Global technical regulation No. 9 (Pedestrian safety)

Proposal for Amendment 2

Submitted by the expert from Japan*

FlexPLI; Dimensions and C.G. locations of femur, knee joint, and tibia (Side view)

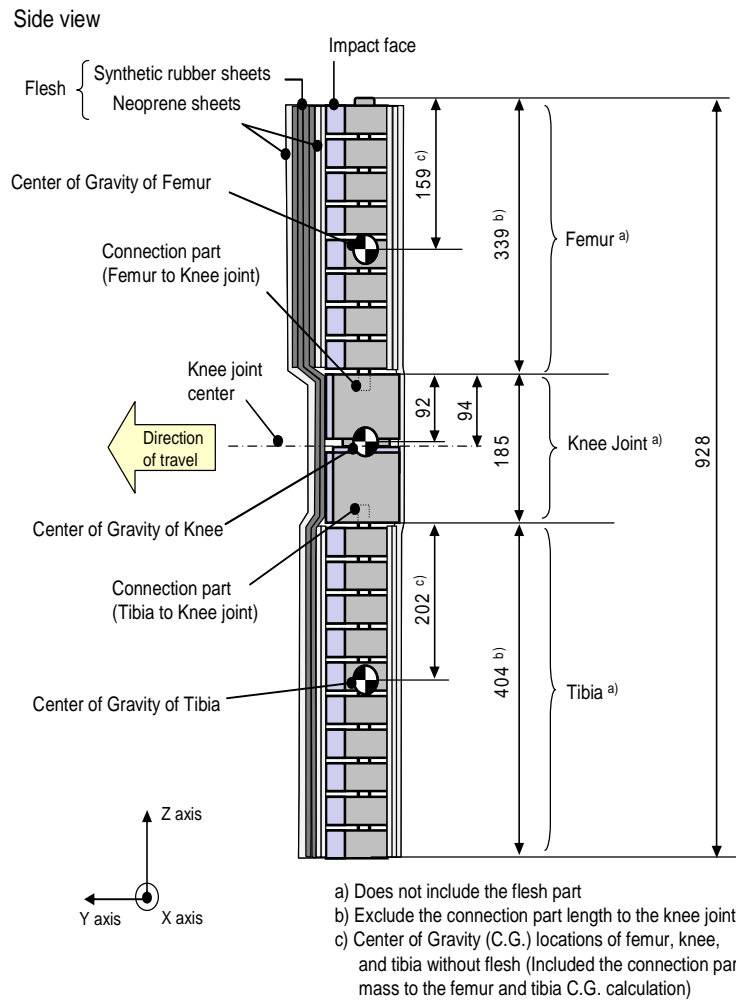
The lower legform impactor shall consist of flesh, flexible long bone segments (representing femur and tibia), and a knee joint as shown in Figure 13.

The overall length of the impactor shall be 928 ± 3 mm, having a required mass of 13.2 ± 0.7 kg including flesh. The length of the femur, knee joint, and tibia shall be 339 ± 2 mm, 185 ± 1 mm, and 404 ± 2 mm respectively. The knee joint centre position shall be 94 ± 1 mm from the top of the knee joint.

The centre of gravity of the femur and tibia without flesh, including the connection part to the knee joint, shall be 159 ± 8 mm and 202 ± 10 mm respectively from the top, but not including the connection part to the knee joint, of each part as shown in Figure 13. The centre of gravity of the knee shall be 92 ± 5 mm from the top of the knee joint as shown in Figure 13.

Figure 14
FlexPLI; femur, tibia, and knee dimensions (Top view)

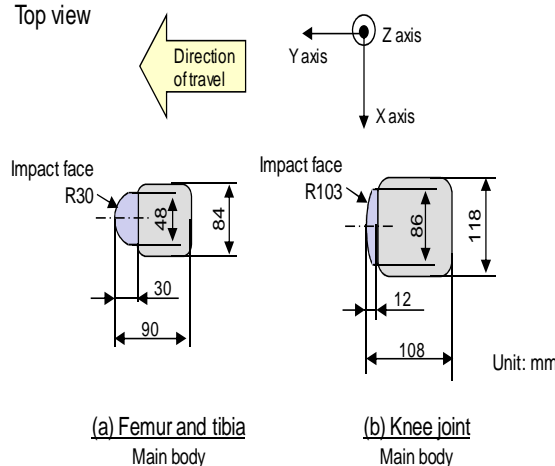
6.3.1.2.1. The cross-sectional shape perpendicular to the Z axis of the femur and tibia main bodies shall be 90 ± 2 mm in width along the Y axis, and 84 ± 1 mm in width along the X axis as shown in Figure 14 (a). The impact face shall be 30 ± 1 mm in radius, 30 ± 1 mm in width along the Y axis, and 48 ± 1 mm in width along the X axis as shown in Figure 14 (a).

6.3.1.2.2. The cross-sectional shape perpendicular to the Z axis of the knee joint shall be 108 ± 2 mm in width along the Y axis, and 118 ± 1 mm in width along the X axis as shown in Figure 14 (b). The impact face shall be 103 ± 1 mm in radius, 12 ± 1 mm in width along the Y axis, and 86 ± 1 mm in width along the X axis as shown in Figure 14 (b).

Figure 15
FlexPLI; flesh dimensions

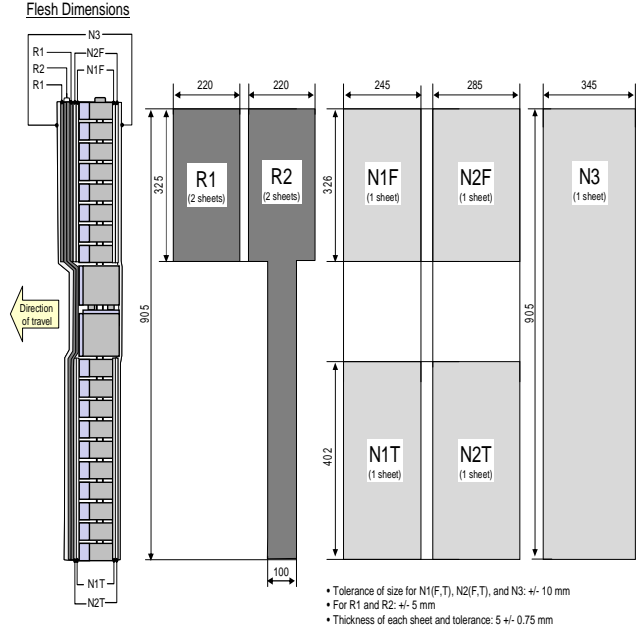
6.3.1.2.4. For each test, the impactor (femur, knee joint, and tibia) shall be covered by flesh composed of synthetic rubber sheets (R1, R2) and neoprene

sheets (N1F, N2F, N1T, N2T, N3) as shown in Figure 15. The sheets are required to have a compression characteristic as shown in Figure 16. The compression characteristic shall be checked using the same batch of sheets as those used for the impactor flesh. The size of the sheets shall be within the requirements described in Figure 16.

Figure 17
FlexPLI; instrument locations

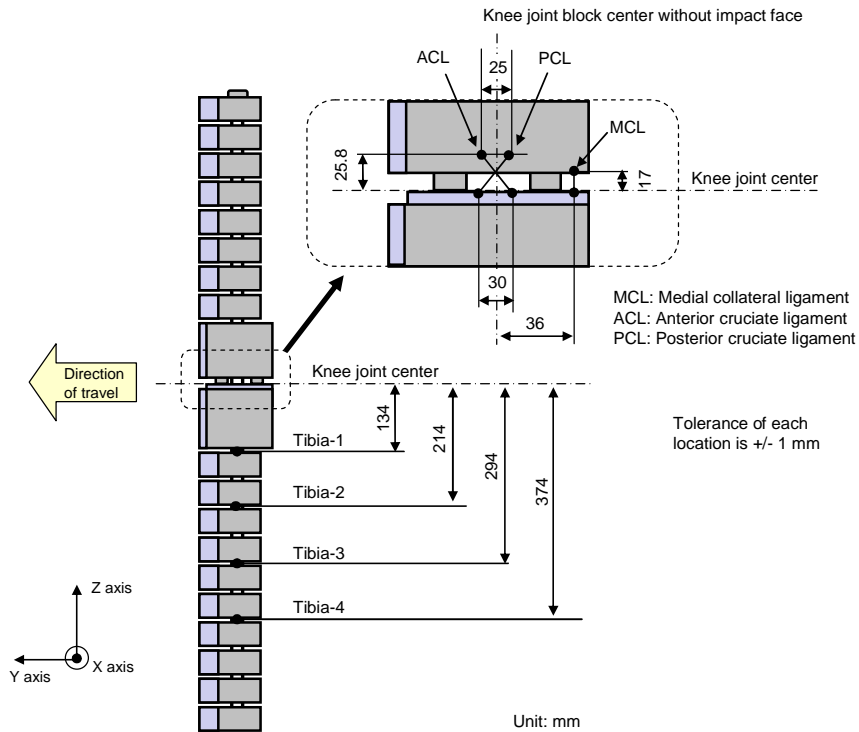
- 6.3.1.2.6. Lower legform instrumentation
 - 6.3.1.2.6.1. Four transducers shall be installed in the tibia to measure bending moments applied to the tibia. The sensing locations of each of the transducers are as follows: tibia-1: 134 ± 1 mm, tibia-2: 214 ± 1 mm, tibia-3: 294 ± 1 mm and tibia-4: 374 ± 1 mm below the knee joint centre respectively as shown in Figure 17. The measurement axis of each transducer shall be the X axis of the impactor.

- 6.3.1.2.6.2. Three transducers shall be installed in the knee joint to measure elongations of the medial collateral ligament (MCL), anterior cruciate ligament (ACL), and posterior cruciate ligament (PCL). The measurement locations of each transducer are shown in Figure 17. The measurement locations shall be within ± 3 mm along the X axis from the knee joint centre.

Tolerances of angles for the lower legform impactor at the time of the first impact (see paragraphs 7.1.2.2. and 7.1.2.3.2.)

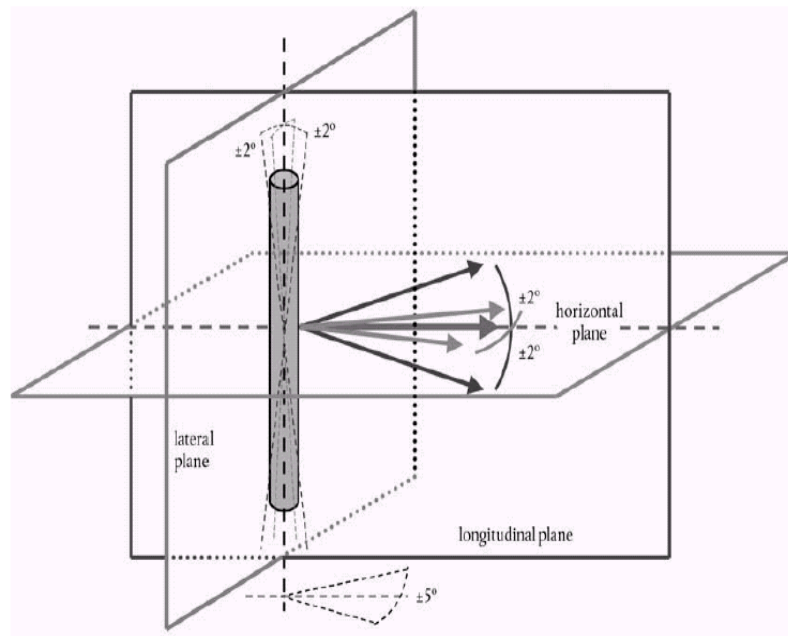
7.1.2.2. **The direction of the impact velocity vector shall be in the horizontal plane and parallel to the longitudinal vertical plane of the vehicle. The tolerance for the direction of the velocity vector in the horizontal plane and in the longitudinal plane shall be $\pm 2^\circ$ at the time of first contact. The axis of the impactor shall be perpendicular to the horizontal plane, with a roll and pitch angle tolerance of $\pm 2^\circ$ in the lateral and longitudinal plane. The horizontal, longitudinal and lateral planes are orthogonal to each other (see Figure 23).**

- 7.1.2.3.2. At the time of first contact the impactor shall have the intended orientation about its vertical axis, for the correct operation of its knee joint, with a yaw angle tolerance of $\pm 5^\circ$ (see Figure 23).
- 7.1.2.3.3. At the time of first contact the centre line of the impactor shall be within a ± 10 mm tolerance to the selected impact location.
- 7.1.2.3.4. During contact between the impactor and the vehicle, the impactor shall not contact the ground or any object which is not part of the vehicle.
- 7.1.2.4. The impact velocity of the impactor when striking the bumper shall be 11.1 ± 0.2 m/s. The effect of gravity shall be taken into account when the impact velocity is obtained from measurements taken before the time of first contact.”

Figure 24
FlexPLI to bumper tests for complete vehicle in normal ride attitude (left) and for cut-body mounted on supports (right) (see paragraph 7.1.2.3.)

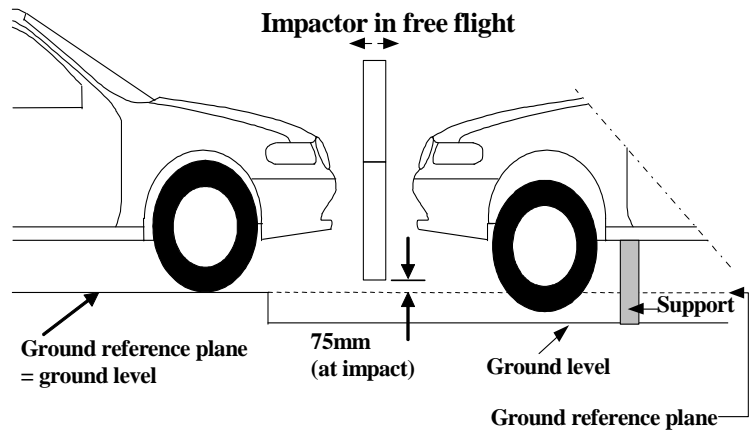
7.1.2.3. **The bottom of the impactor shall be at 75 mm above ground reference plane at the time of first contact with the bumper (see Figure 24), with a ± 10 mm tolerance. When setting the height of the propulsion system, an allowance must be made for the influence of gravity during the period of free flight of the impactor.**

“Figure 31
Requirement corridor of femur and tibia in static certification test (see paragraph 8.2.1.2.)

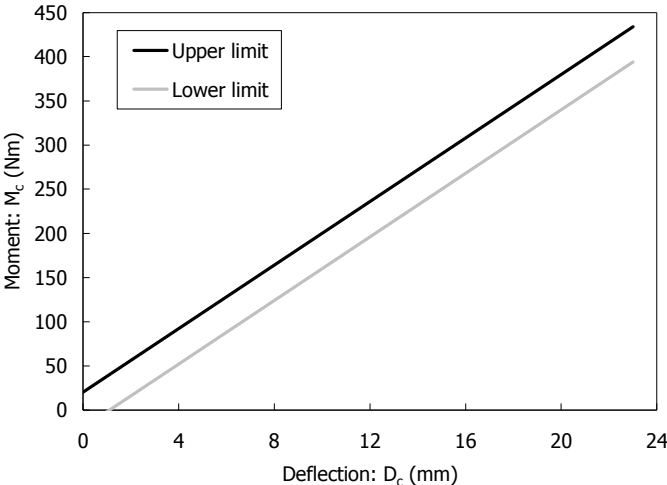
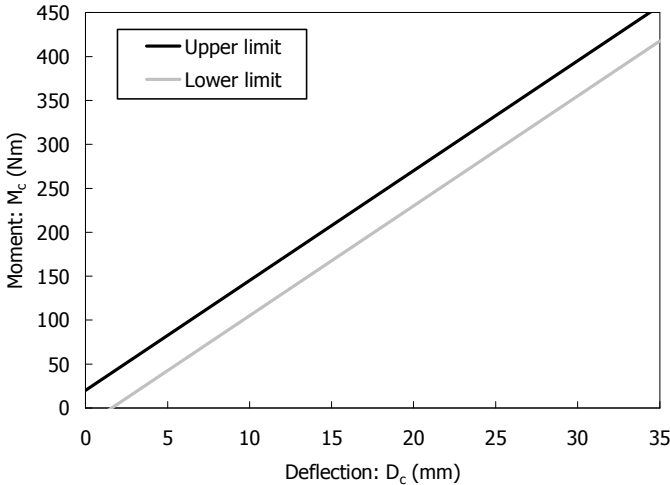
8.2.1.2. When the femur and tibia of the impactor are loaded in bending in accordance with paragraph 8.2.1.4., the applied moment and generated deflection at the centre of the femur and tibia (M_c and D_c) shall be within the corridors shown in Figure 31.

Figure 32
Requirement corridors for knee joint in static certification test (see paragraph 8.2.1.3.)

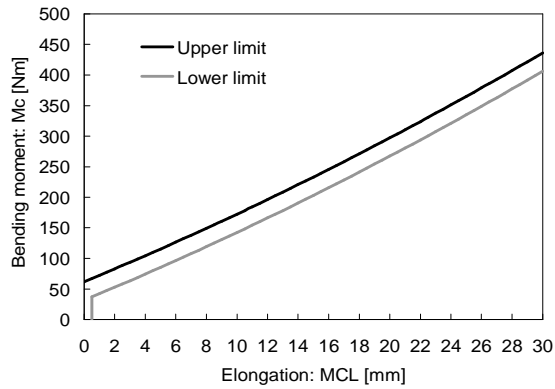
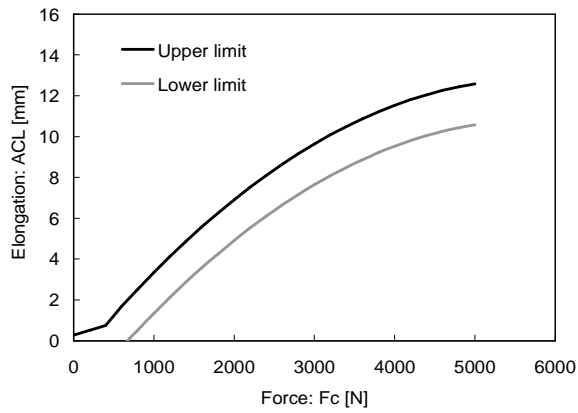
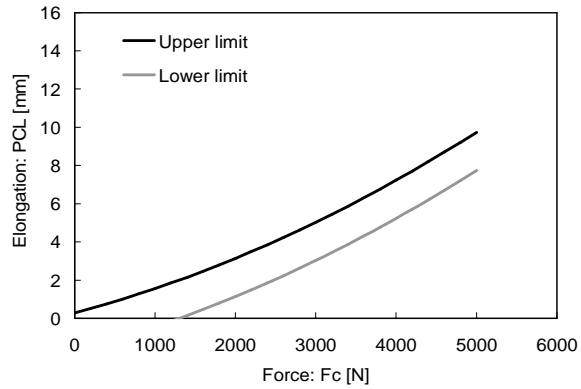
8.2.1.3. When the knee joint of the impactor is loaded in bending in accordance with paragraph 8.2.1.5., the MCL, ACL, and PCL elongations and applied bending moment or force at the centre of the knee joint (M_c or F_c) shall be within the corridors shown in Figure 32.

Figure 33
Test set-up for femur in static certification tests (see paragraph 8.2.1.4.)

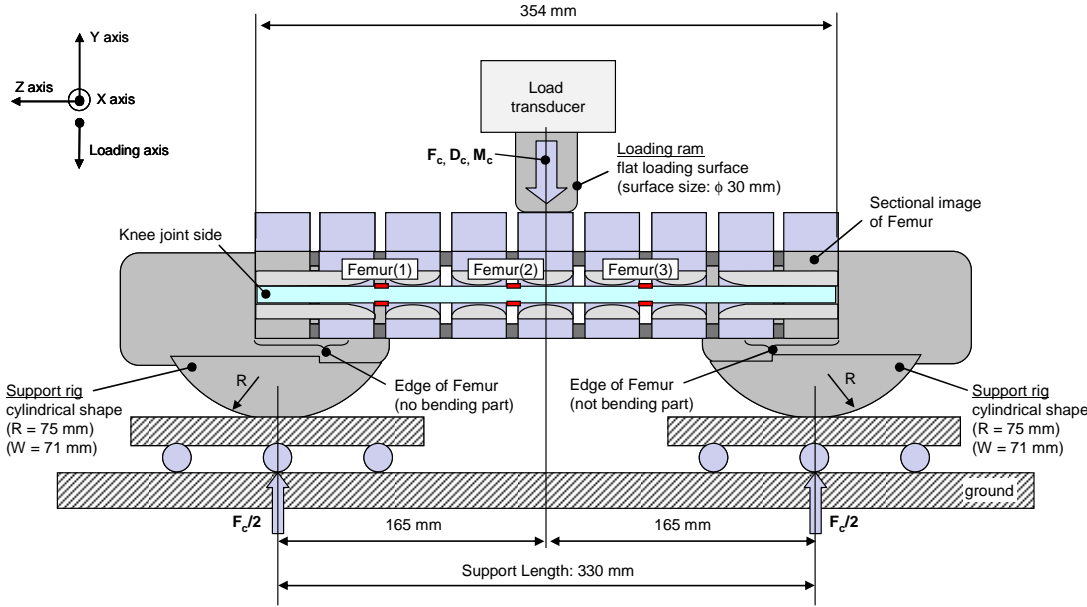
8.2.1.4. The edges of the femur and tibia, not bending parts, shall be mounted to the support rig firmly as shown in Figure 33 and Figure 34. The Y axis of the impactor shall be parallel to the loading axis within $180 \pm 2^{\circ}$ tolerance. In order to avoid friction errors, roller plates shall be set underneath the support rigs.

The centre of the loading force shall be applied at the centre of the femur and tibia within $\pm 2^{\circ}$ tolerance along the Z axis. The force shall be increased at a rate between 10 and 100 mm/minute until the bending moment at the centre part (M_c) of the femur or tibia reaches 400 Nm.

Figure 35
 Test set-up for knee joint in static certification test (see paragraph 8.2.1.5.)

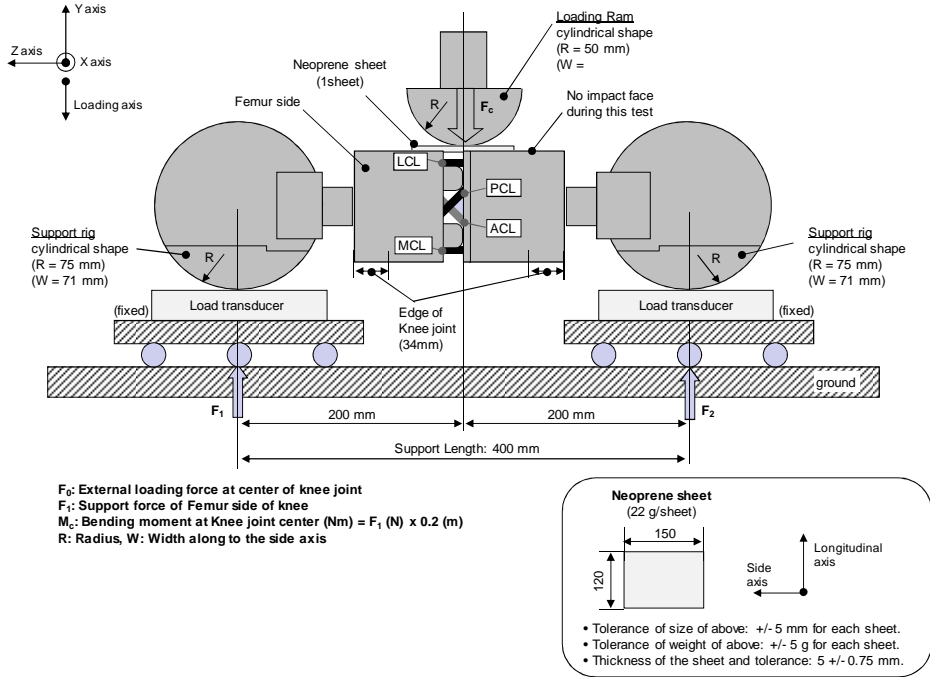
8.2.1.5. The edges of the knee joint, not bending parts, shall be mounted to the support rig firmly as shown in Figure 35. The Y axis of the impactor shall be parallel to the loading axis within $180 \pm 2^{\circ}$. In order to avoid friction errors, roller plates shall be set underneath the support rigs. To avoid impactor damage, a neoprene sheet shall be set underneath the loading ram and the impactor face of the knee joint which is described in the Figure 14 shall be removed. The neoprene sheet used in this test shall have compression characteristics as shown in Figure 16.

The centre of the loading force shall be applied at the centre of the knee joint within $\pm 2^{\circ}$ tolerance along the Z axis. The external load shall be increased at a rate between 10 and 100 mm/minute until the bending moment at the centre part of the knee joint (M_c) reaches 300 Nm.

Figure 36
 Test set-up for dynamic lower legform impactor certification test, pendulum type (see paragraph 8.2.2.4.)

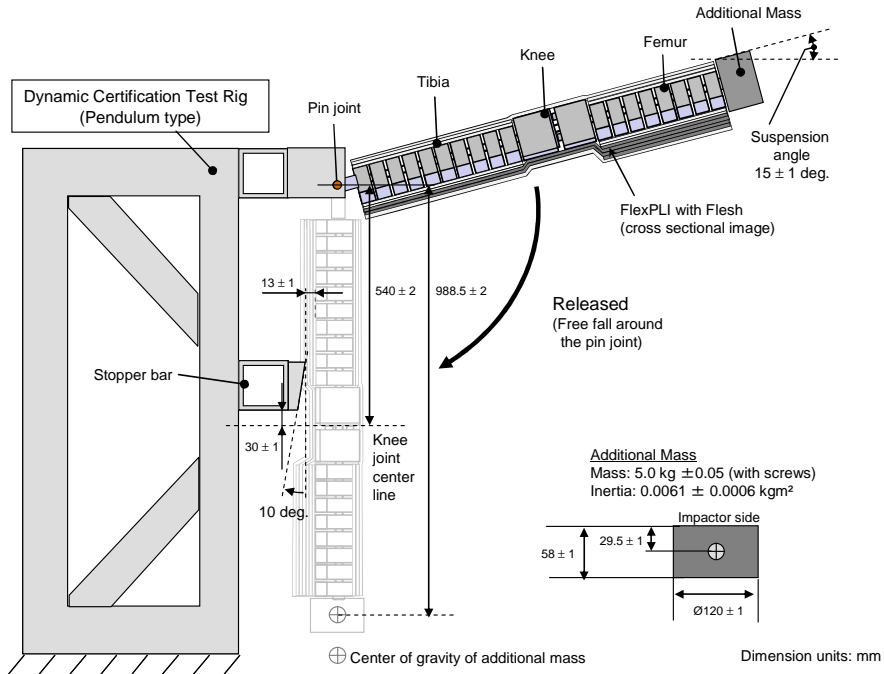
- 8.2.2.4. Test procedure
- 8.2.2.4.1. The impactor, including flesh, shall be suspended from the dynamic certification test rig $15 \pm 1^\circ$ upward from the horizontal as shown in Figure 36. The impactor shall be released from the suspended position, whereupon the impactor falls freely against the pin joint of the test rig as shown in Figure 36.

- 8.2.2.4.2. The knee joint centre of the impactor shall be 30 ± 1 mm below the bottom line of the stopper bar, and the tibia impact face shall be located 13 ± 1 mm from the front upper edge of the stopper bar when the stopper block is removed from the stopper bar and then hung from the impactor without any contact (see Figure 36).

Figure 37
Test set-up for dynamic lower legform impactor certification test, inverse type (see paragraph 8.2.3.4.)

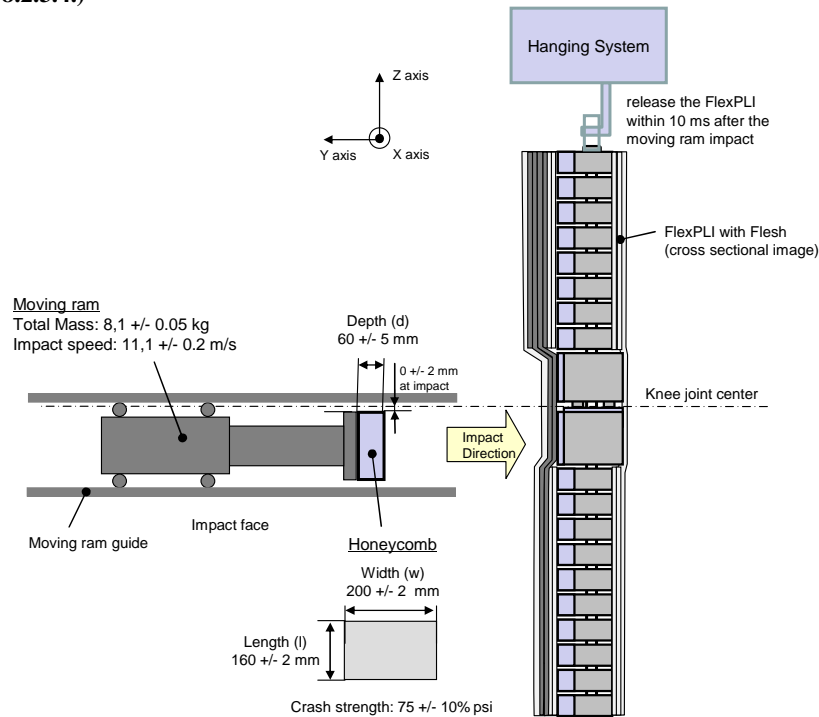
- 8.2.3.4. Test procedure
- 8.2.3.4.1. The fully assembled FlexPLI (with flesh and skin) shall be stationary suspended vertically from a test rig as shown in Figure 37. It is then impacted by the upper edge of a linearly guided Al honeycomb impactor, covered by a thin (less than 1 mm thickness) paper cloth, at an impact speed of $11,1 \pm 0,2$ m/s. The legform is to be released from the test rig within 10 ms after the time of first contact to ensure a free flight condition.

- 8.2.3.4.2. The honeycomb of 5052 alloy, which is attached in front of the moving ram, shall have a crash strength of 75 ± 10 per cent psi and dimensions of $l = 200 \pm 2$ mm, $w = 160 \pm 2$ mm and $d = 60 \pm 5$ mm. To ensure a consistent and good level of repeatability, the honeycomb should either have a 3/16 inch cell size in combination with a density of 3.1 pcf or a 1/4 inch cell size in combination with a density of 2.3 pcf or a 3/16 inch cell size in combination with a density of 2.0 pcf.

- 8.2.3.4.3. The upper edge of the honeycomb face is to be in line with the rigid plate of the linearly guided impactor. At time of first contact, the upper edge of the honeycomb is to be in line with the knee joint centre line within a vertical tolerance of 0 ± 2 mm. The honeycomb shall not be excessively handled or deformed before the impact test.
